Our ref: SSD-9261283

Subject: Wallaroo Solar Farm (SSD- 9261283) – Questions on Notice and Request for Clarification

Figure 3: Access Route from Port Botany to Site

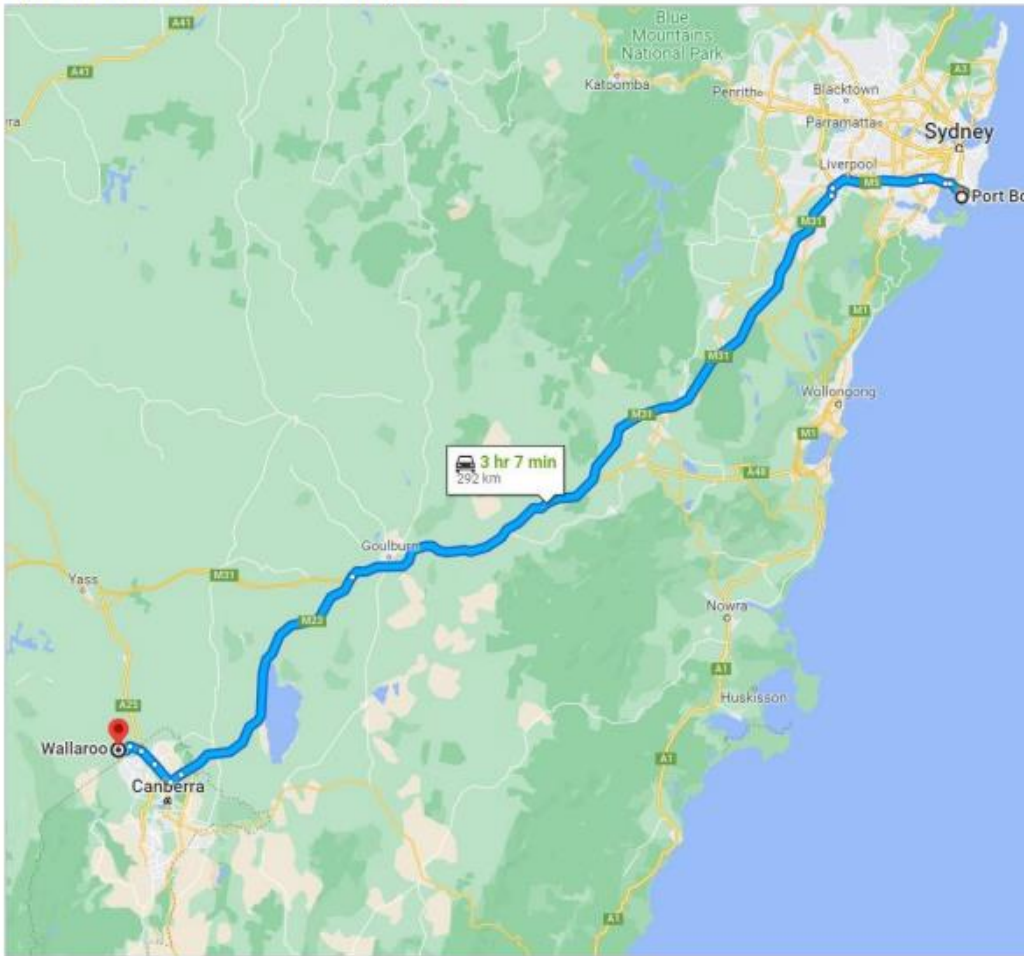
3. ***The proposed access routes in their entirety for each vehicle type including heavy vehicles, oversize overmass (OSOM) vehicles and light vehicles (e.g., staff vehicles).***

The proposed construction traffic access route from Port Botany to the site is proposed to be via Hume Highway, Federal Highway and Barton Highway. Figure 3 below shows the proposed access route from the port which is the proposed route to be undertaken by heavy vehicles from the port.

The TIA notes a split in vehicle directions for heavy vehicles servicing the site from the local area, not required to access the site from Port Botany (i.e; water trucks). The TIA assessed 30% of these local heavy vehicles arriving daily from the north and 70% coming from the south. Figure 2 of Appendix 6 of the conditions demonstrates that all vehicles, regardless of whether they arrive from the north or south, will access the site via the Barton Highway/Wallaroo Road intersection.
